Section 5

Flood Protection Plan - Phase II
Ambiotec Civil Engineering Group, Inc.
August 2011

Figure 3-2. Existing development floodplain for the URRV/CCDD3 watersheds assuming a 10-yr design rainfall total of 7.48 inches over a 24-hr period over the entire watershed area

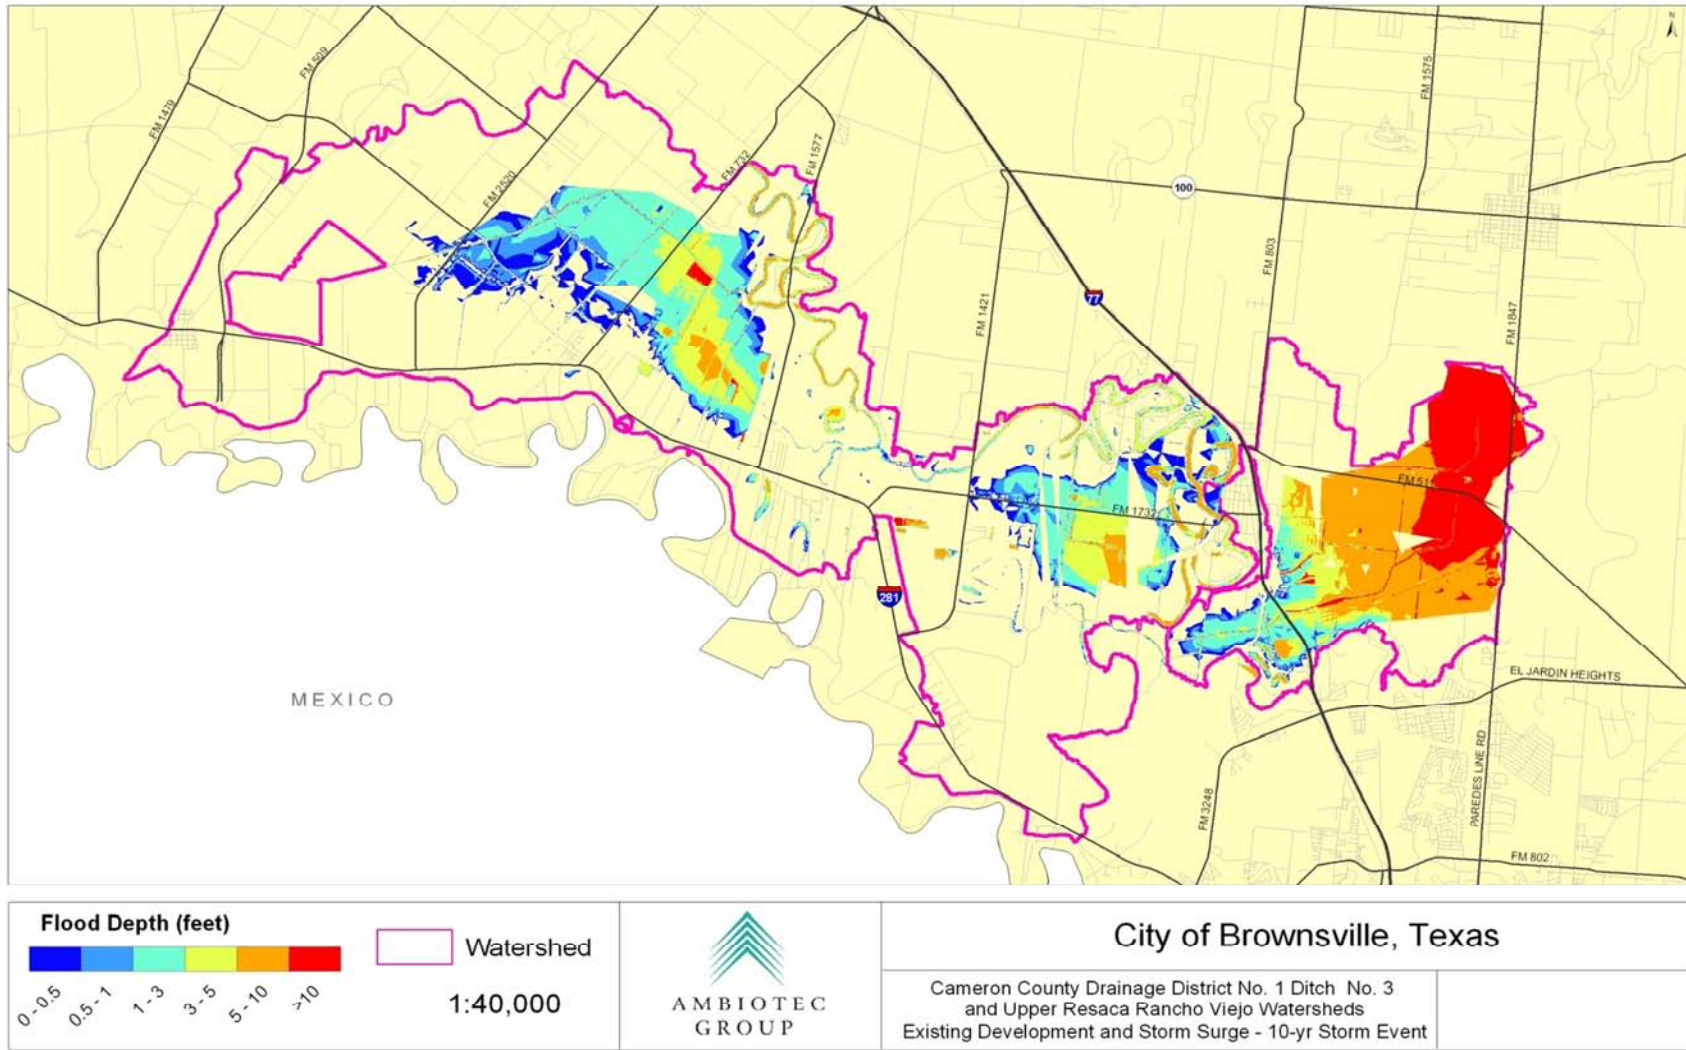
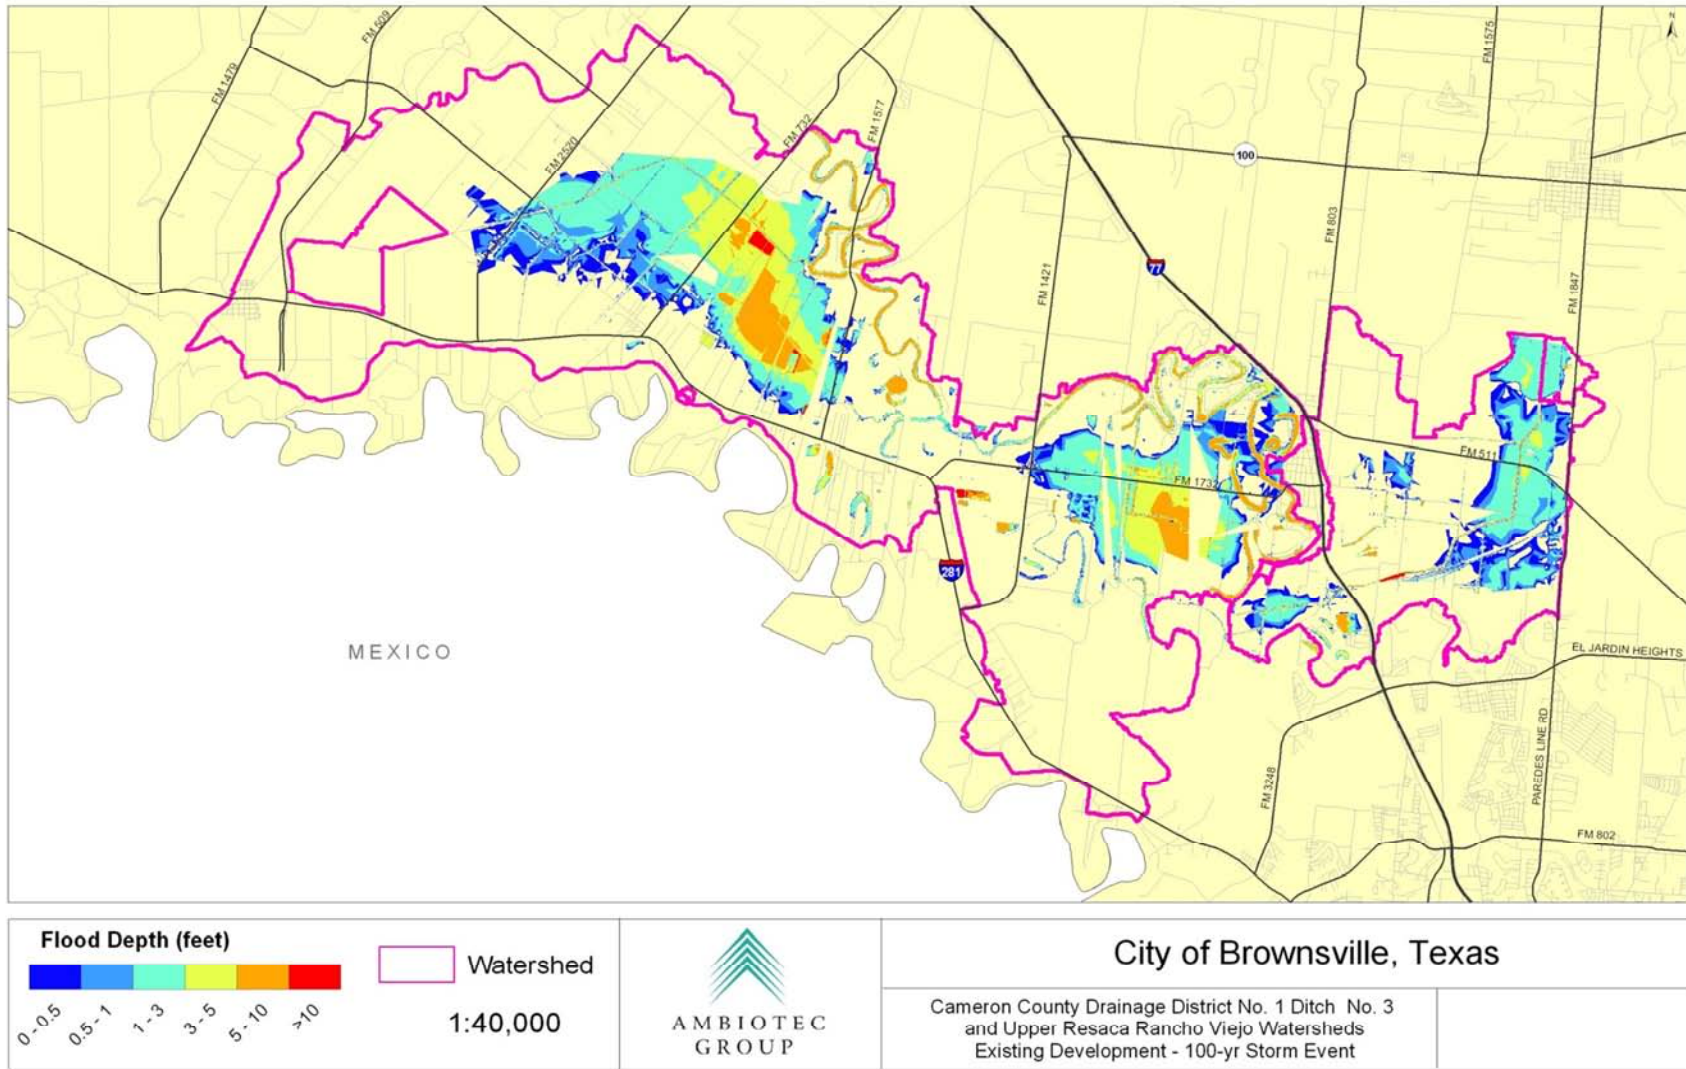
5. Figure 3-2 illustrates the inundation depths associated with existing development and a 10-yr storm event, while Figure 3-3 shows depth of flooding under existing development and the 100-yr storm event. Comparing the two figures seems to indicate that flooding depths are greater under the 10-yr event than the 100-yr event, particularly east of Hwy 77. Please explain.

The incorrect image was inserted into Figure 3-2 and instead of showing the 10-yr floodplain under existing conditions it was showing the 10-yr floodplain under maximum hurricane storm surge conditions. This error has been corrected and all figures now display what is described in the text/captions.

Figure 5-1. Floodplain for the URRV/CCDD3 watersheds under extreme storm surge conditions (28-ft) assuming a 10-yr design rainfall total of 7.48 inches over a 24-hr period over the entire watershed area

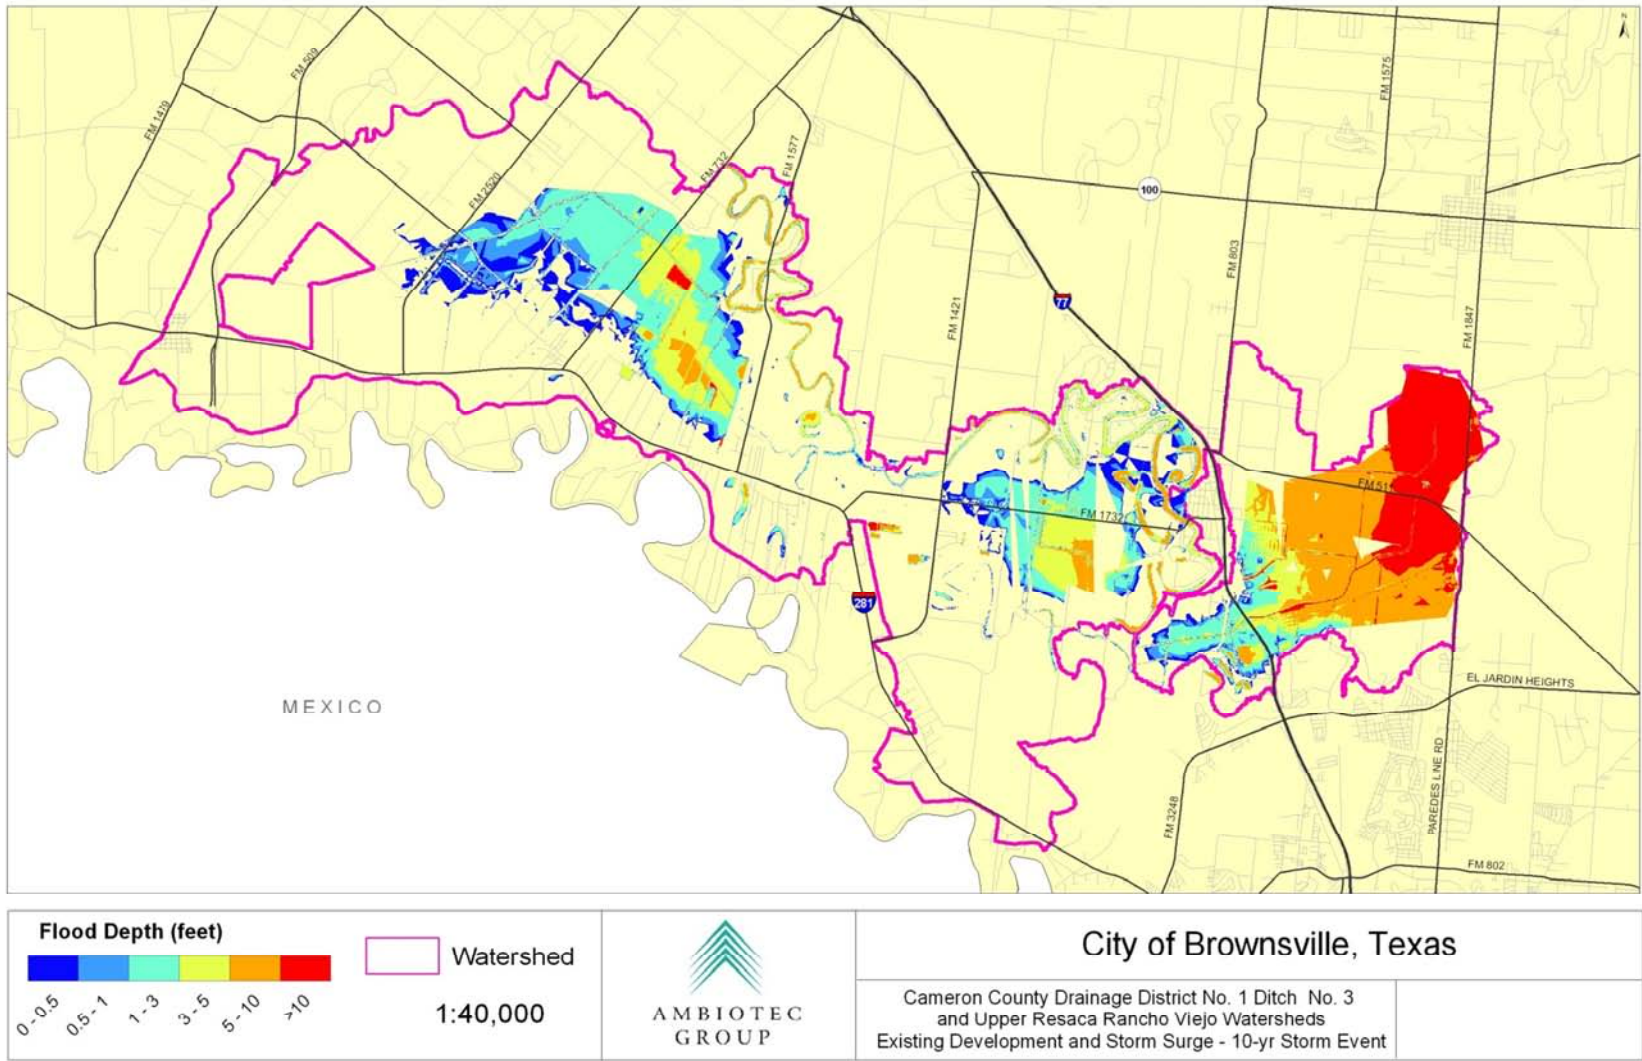
6. In comparing the depths of flooding indicated by Figure 3-2 to Figure 5-1, which illustrates flood depths under the same development and storm event scenarios but adds the maximum hurricane storm surge, the two figures appear to be identical. Please explain why storm surge would have no, or minimal, impact to depth of flooding.
